# ES\_P89LPC914

Errata sheet P89LPC914

Rev. 02 — 23 February 2010

Fig 1. Flowchart ICP global erase

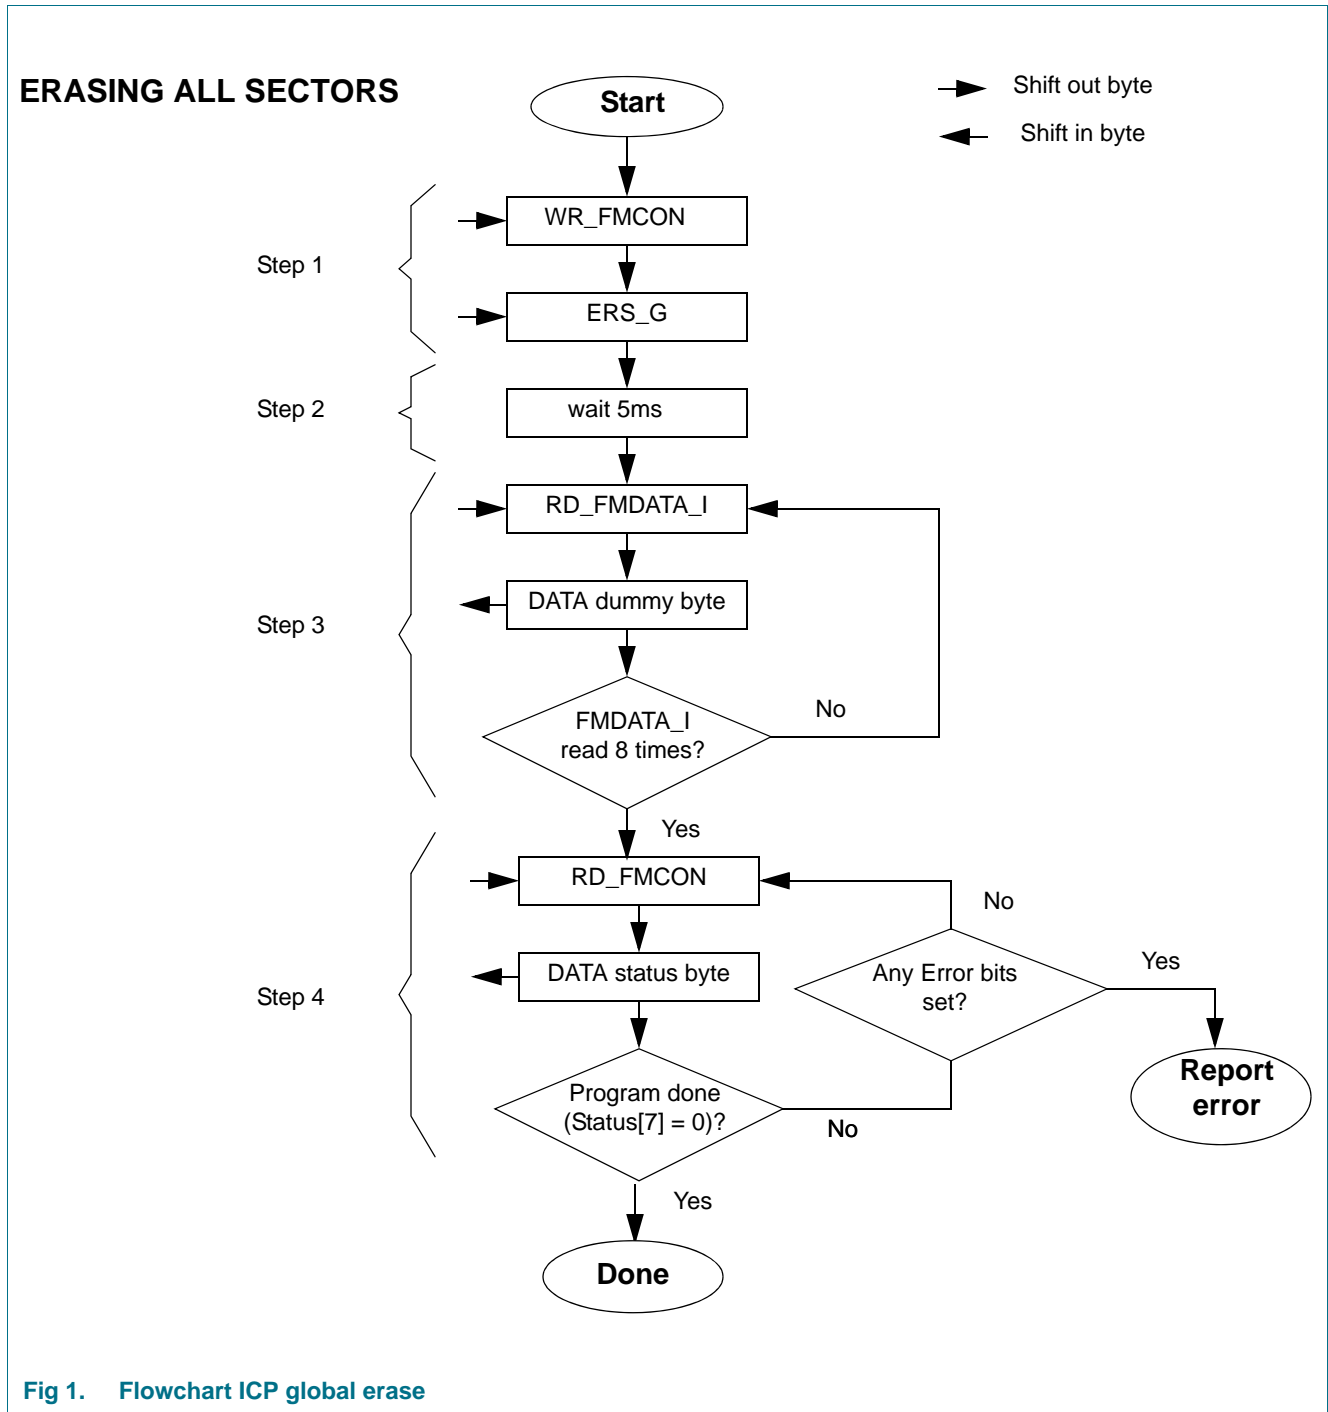
When giving the Erase Global command through the ICP interface the P89LPC914 will not clear the busy flag and stay busy forever.

The workaround can be done in 4 steps:

Step 1: Shift out the WR\_FMCON command followed by the Erase Global opcode.

Step 2: Wait 5ms.

Step 3: Do 8 dummy reads with the RD\_FMDATA\_I command.

Step 4: Read FMCON until the busy flag gets cleared.

Please also see [Figure 1](#).
